Official Transcript of Proceedings
NUCLEAR REGULATORY COMMISSION

Title: Advisory Committee on Reactor Safeguards
 US-APWR Subcommittee: Open Session

Date: Thursday, April 25, 2013

US-APWR SUBCOMMITTEE

Data Flow To External Networks (1/2)

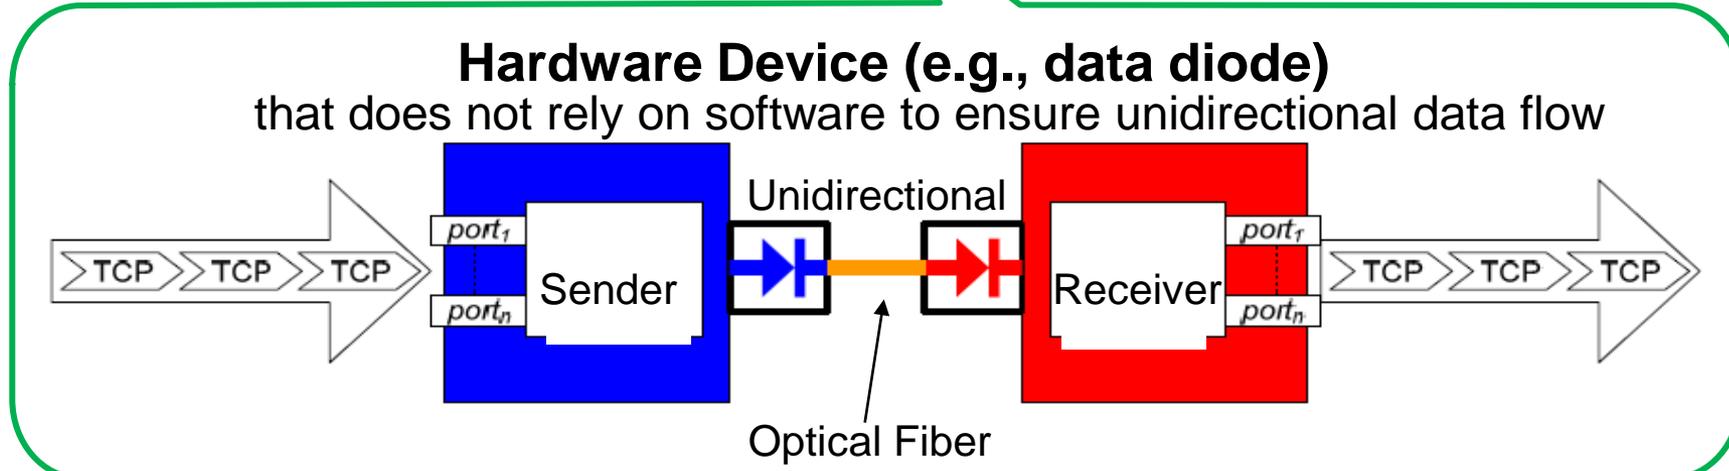
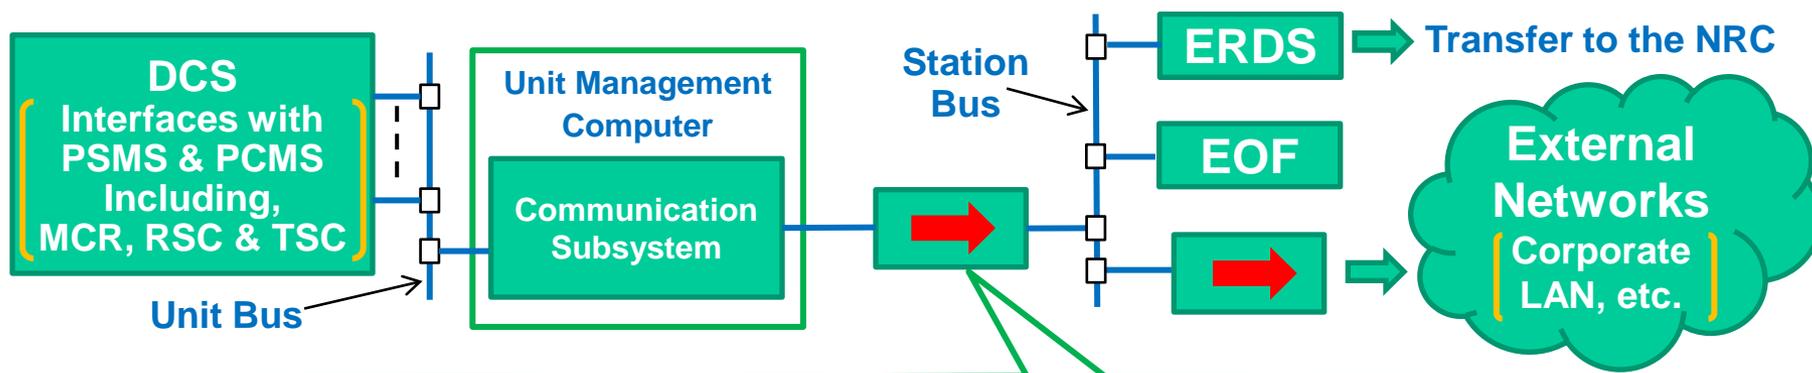
5 MR. SAMPLES: Let's take a picture of this
6 and, well you're not going to see this in DCD Rev 3,
7 we have done it yet, but we're going to add a hardware
8 based unidirectional device to this system.

9 If you see the data communication system,
10 unit management computer station bus, right there
11 between the unit management computer and the station
12 bus we're going to add this hardware device.

6 MR. SAMPLES: We're planing for DCD Rev 4.

DCD Figure 7.3-1

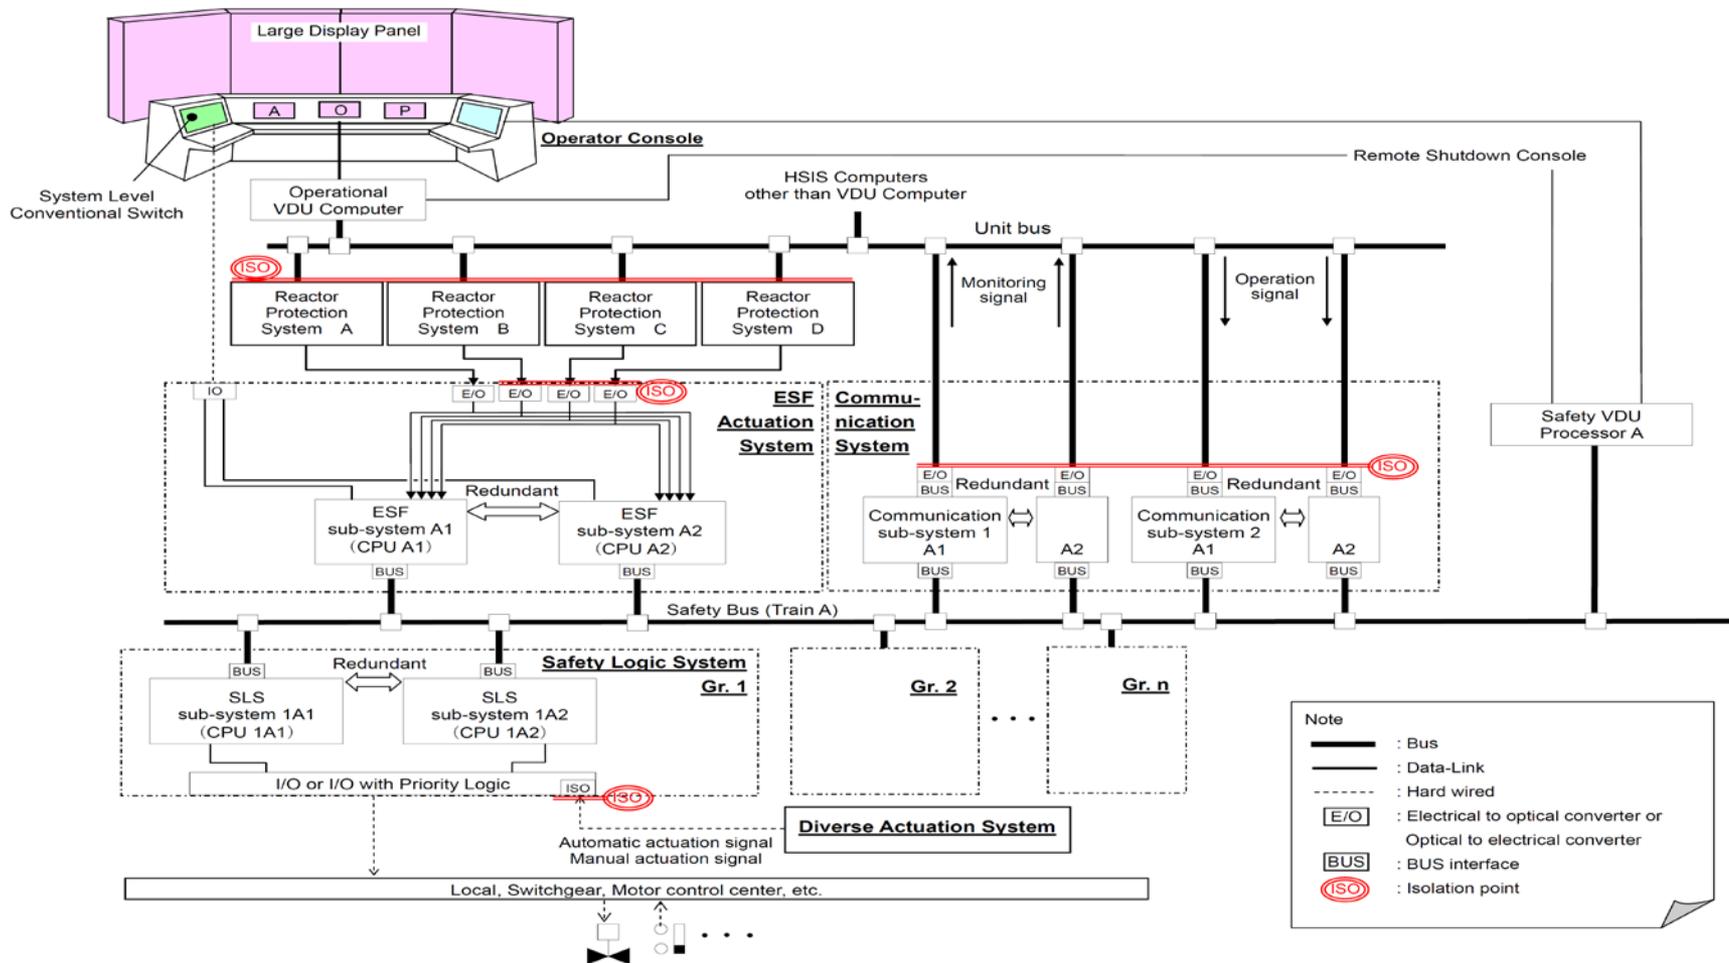
11 MEMBER BROWN: Before you leave, what's a
12 Group 2, 3, out to N? You show these multiple groups
13 but they're all still on the same safety bus.

5 MR. SCAROLA: Well there are two
6 constraints. There is a response-time constraint, so
7 we want to make sure that one controller group pair is
8 not overloaded and running in excessive response-time
9 because we have to trip these things in 300 milliseconds,
10 or get them actuated in 300 milliseconds.

11 And then you have the issue of functional
12 distribution to make sure that if one group were to
13 spuriously actuate, we wouldn't get an unusual event
14 in the plant that's not bounded by the safety analysis.

Information Systems Important to Safety

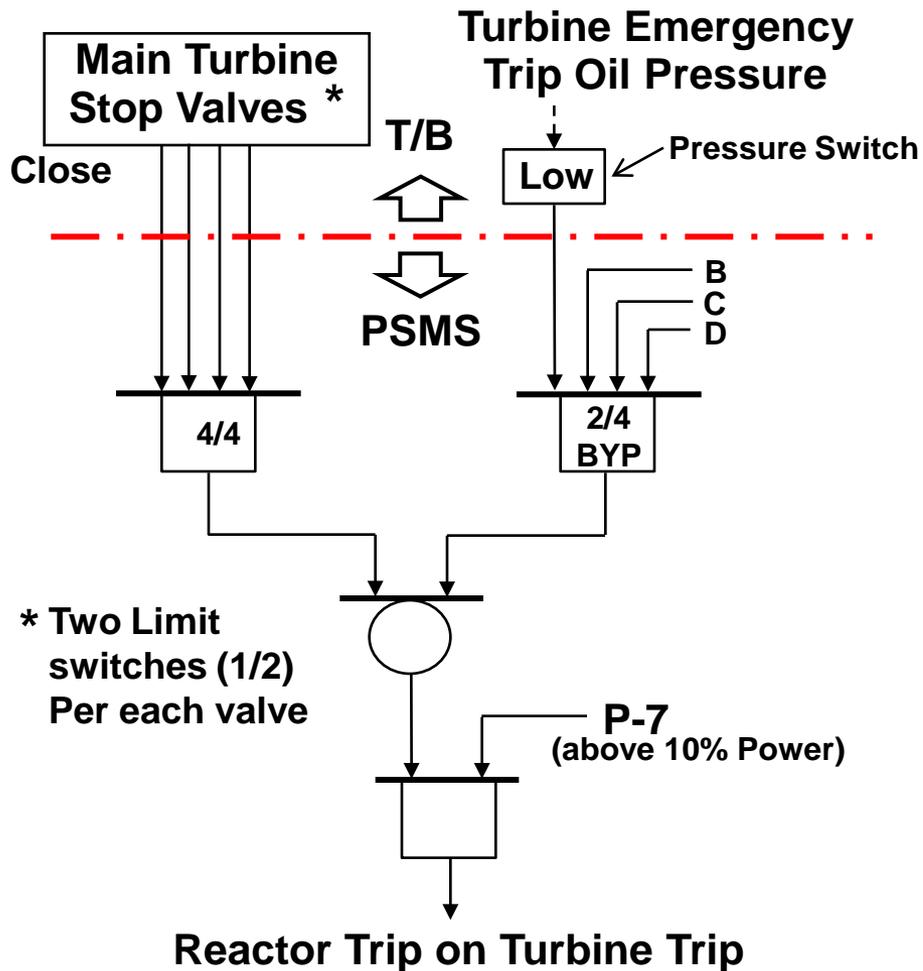
5 Why didn't you provide the trending
6 capability over on the safety VDU side? The reason I'm
7 interested is the PCMS is non-safety related.

7 So that's the reason I bring up the question
8 about why the trending information isn't available over
9 on the safety side of the plant.

1 Chapter 18 issue, but it's also a Chapter 7 issue. But
2 if they are required we will add trends, but right now
3 we have not seen any need for it.
